AGENDA
CITY OF KENTWOOD PLANNING COMMISSION
TUESDAY, NOVEMBER 26, 2024
KENTWOOD COMMISSION CHAMBERS
4900 BRETON AVENUE, SE
7:00 P.M.

RE: ***Raising Cane's
Site Plan and Special Land Use Review
3650 – 28th Street
Kentwood, MI***

The responses below address the comments received on November 7, 2024 from the City of Kentwood's Engineering Department following the planning level review for the Raising Cane's Special Land Use and Site Plan Review. Below is a summary of the actions taken in response to these comments.

RAISING CANE'S C1283
3650 28TH SE
CITY OF KENTWOOD
KENT COUNTY, MI 49512

SOIL EROSION AND SEDIMENTATION CONTROL PLAN

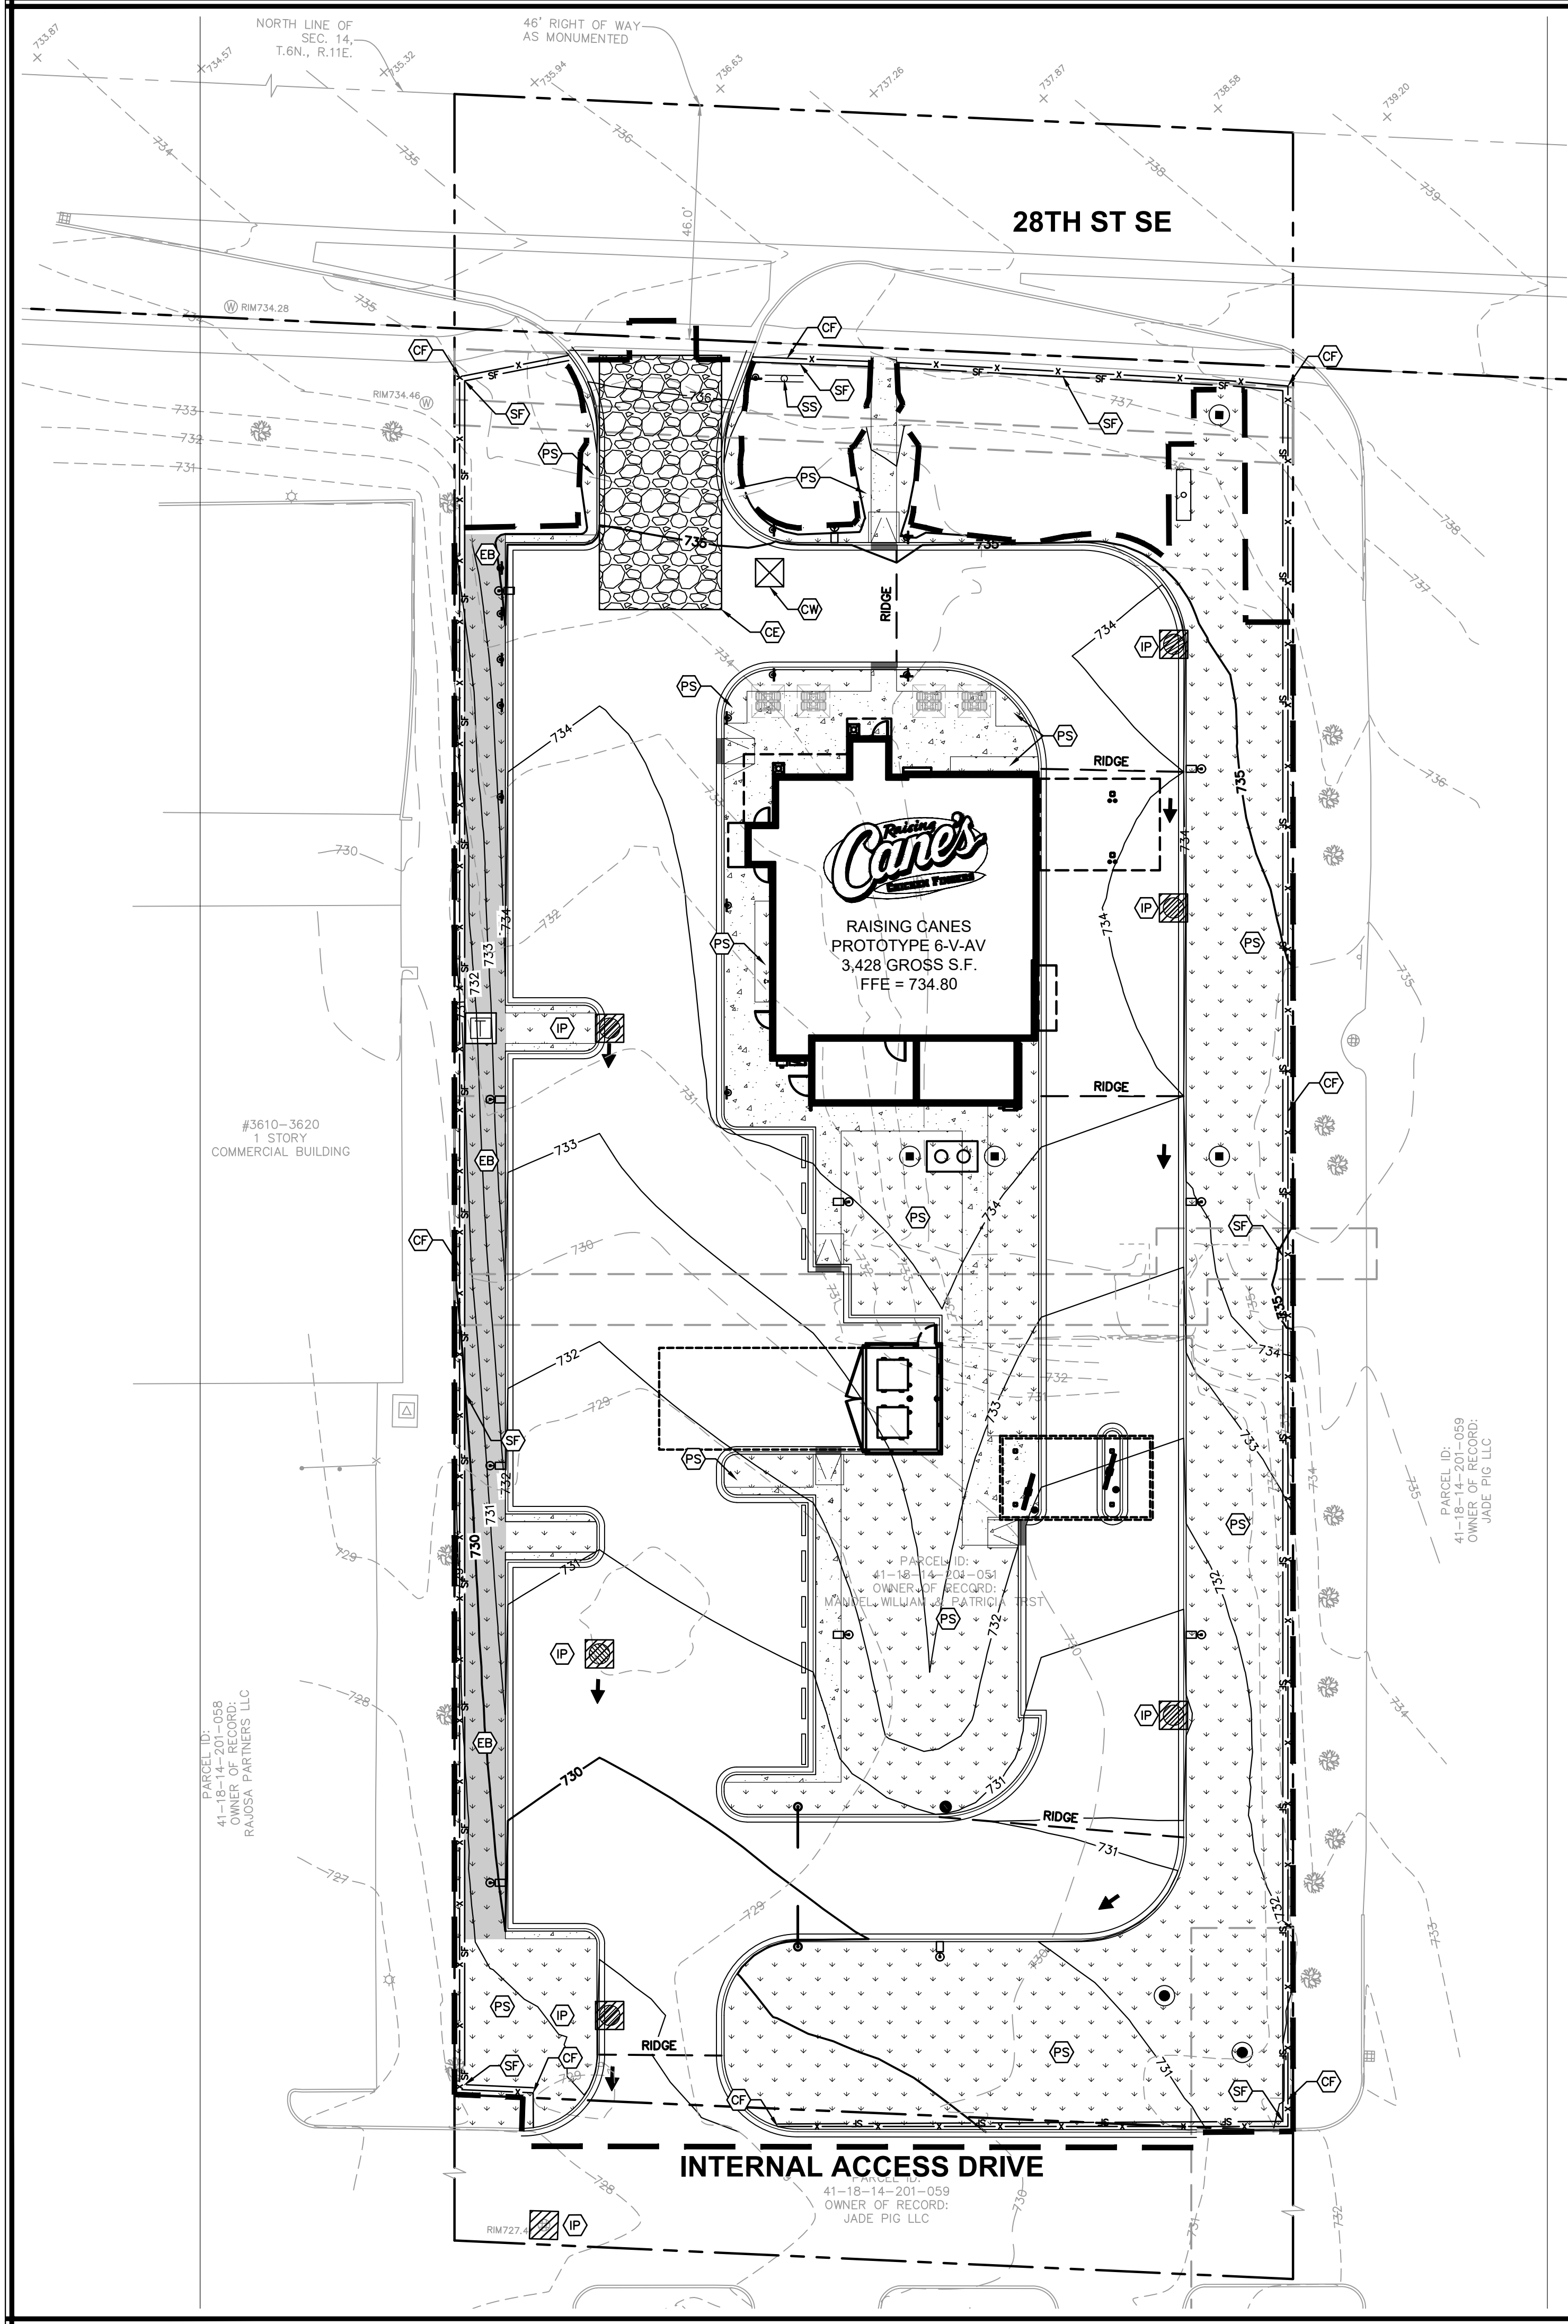
2. Per the requirements of Part 91 of Public Act 451, all proposed grading and soil erosion controls must be shown on a sheet(s) titled, at least in part, "SOIL EROSION AND SEDIMENTATION CONTROL PLAN". This plan should show surface features related to grading and soil erosion and sediment control. The SESC Plan may be combined with other plans and improvements as long as clarity is retained. Two (2) copies of this sheet, once approved, will need to accompany the application for an earth change.
Response: Erosion control plan sheet has been added under the name "SOIL EROSION AND SEDIMENTATION CONTROL PLAN" on C3.0. The existing surface contours as well as proposed surface contours are shown on this plan sheet.

3. Include a written description of the soil types of the exposed land area contemplated for an earth change.
Response: A site soil analysis description has been added to the erosion control plan per geotechnical report narratives. See Sheet C3.0.

4. Place a note on the soil erosion control plan to indicate that existing and new catch basins shall be protected with an inlet filter drop (silt sack). Straw bales or fabric placed under the grate are NOT acceptable, and sediment traps alone are not sufficient to provide adequate sediment filtration. Such a note might read, "EXISTING AND NEW CATCH BASINS SHALL BE PROTECTED WITH AN INLET FABRIC DROP (SILT SACK)." Include a simple detail of the proposed silt sack on the Soil Erosion and Sediment Control plan. We can provide you with an acceptable CAD detail upon request.
Response: Note added to Sheet C3.0 under City of Kentwood Erosion Control Notes. Inlet protection detail was added to the Erosion Control Details plan sheet on C3.1.

5. Place the following notes on the soil erosion control plan:
 - ALL SOIL EROSION AND SEDIMENTATION CONTROL MEASURES SHALL COMPLY WITH ARTICLE 2 OF CITY OF KENTWOOD ORDINANCE 78 AND PART 91 OF PUBLIC ACT 451.
Response: Note added to Sheet C3.0 under City of Kentwood Erosion Control Notes.

6. Per the requirements of Part 91 of P.A. 451, place on the soil erosion control plan a bar graph or chart showing the proposed timing and sequence of each proposed earth change. It must include the installation of both permanent and temporary soil erosion and sedimentation controls, as well as the removal of temporary controls. It must also show the sequence of any construction phases.

7. A stone construction exit must also be included as part of the soil erosion control plan. Indicate the location of this exit on the plan, along with a detail. The length of the rock construction exit shall be at least 50 feet and shall consist of a 6-inch minimum layer crushed rock or stone on top of non-woven geosynthetic fabric (MDOT "Heavy Geotextile Liner"). The size of the stone shall be selected so that it cannot get caught between dual truck tires.

Response: A Sequence of Construction Operations table has been added to the erosion control plan on C3.0 that details the construction phases and timing of each phase.

Response: A construction entrance/exit has been added to the northern entrance of the site on the erosion control plan on C3.0. The construction detail for the construction entrance/exit can be found on the erosion control detail sheet on C3.1.

GRADING PLAN

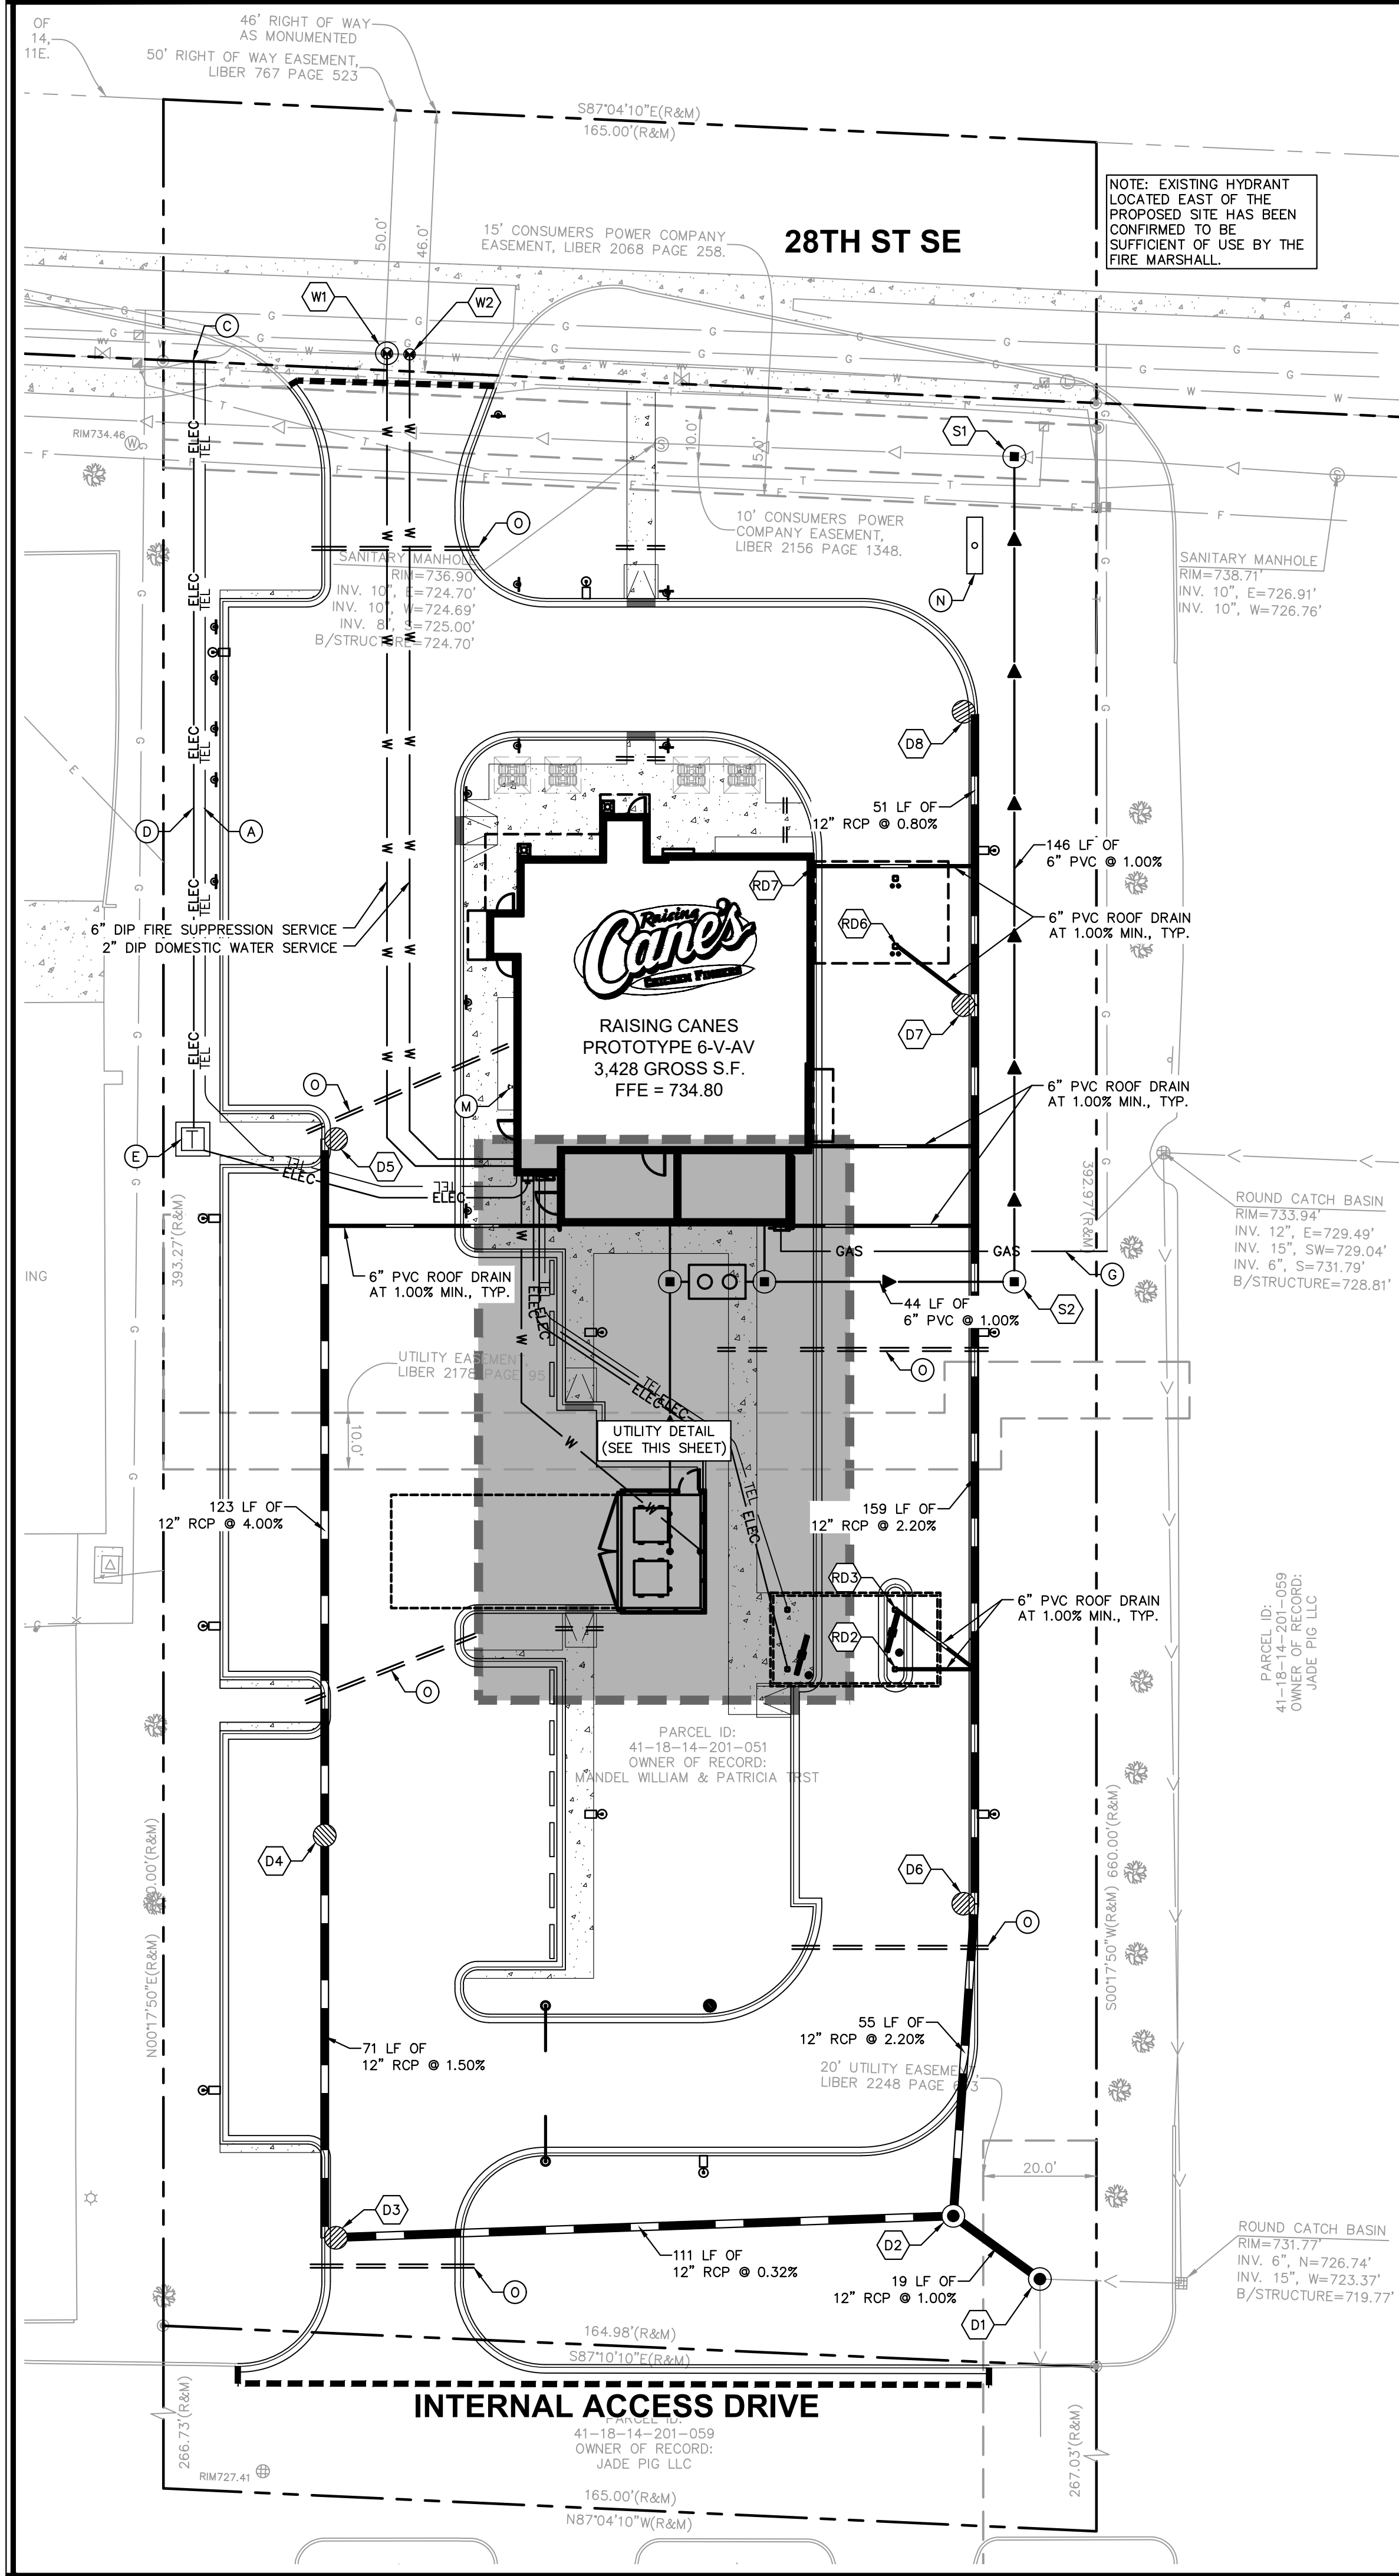
1. Indicate the proposed limits of grading on the site plan. A thick, shaded line works well for this.
Response: The proposed limits of disturbance has been added to the grading plan and is denoted in the plans and on grading legend as a thick dashed line. See sheet C6.0.
